Planning Commission Staff Report

| Project type: | Amended Site Development Plan |
| Description: | <u>Dierbergs The Market Place, Outlot Building 1772 Clarkson Road (Billy G's):</u> Amended Site Development Plan, Landscape Plan, and Amended Architectural Elevations for a restaurant located on an 11.35-acre tract of land located east of Clarkson Road and north of Baxter Road, zoned "C8"- Planned Commercial District. |

**Re: Dierbergs Chesterfield Village (1772 Clarkson Road)
ARB Re-submittal**

Figure 9: Roof Top Screening Diagram

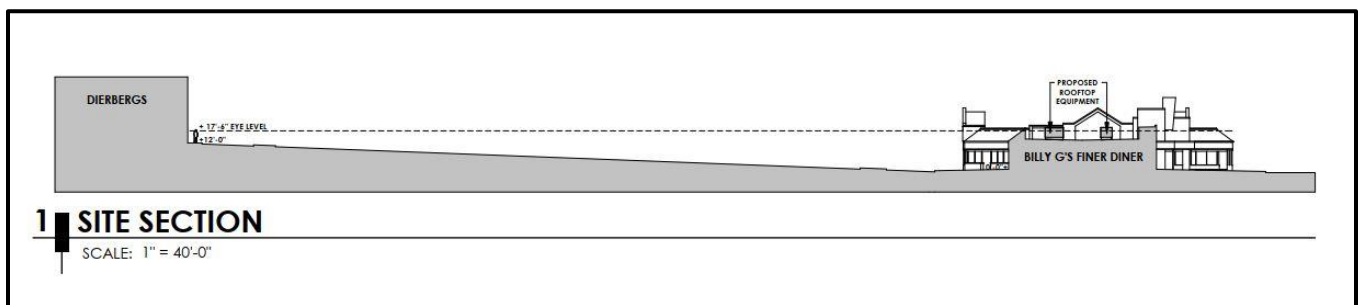
1. Provide a rooftop screening diagram confirming that the proposed parapet walls will completely screen the visibility of the roof-top equipment from the site perimeter.
2. Provide a note on the elevations that the rear material color of the projecting wall element (CP-2 *Nichiha Miraia series "snow"*) will be of a similar color as the front.

1. Attached please find a site section diagram that depicts the screening of the mechanical rooftop units. Furthermore, the applicant agrees that any additional or modified roof top equipment will be properly screened with materials of the same color as the existing building.
2. Please reference sheets ARB 3 & 4, for an added note that states that the back side of parapet walls of the entry element shall be of a similar color as the front material (CP-2, Nichiha Miraia Series "snow")
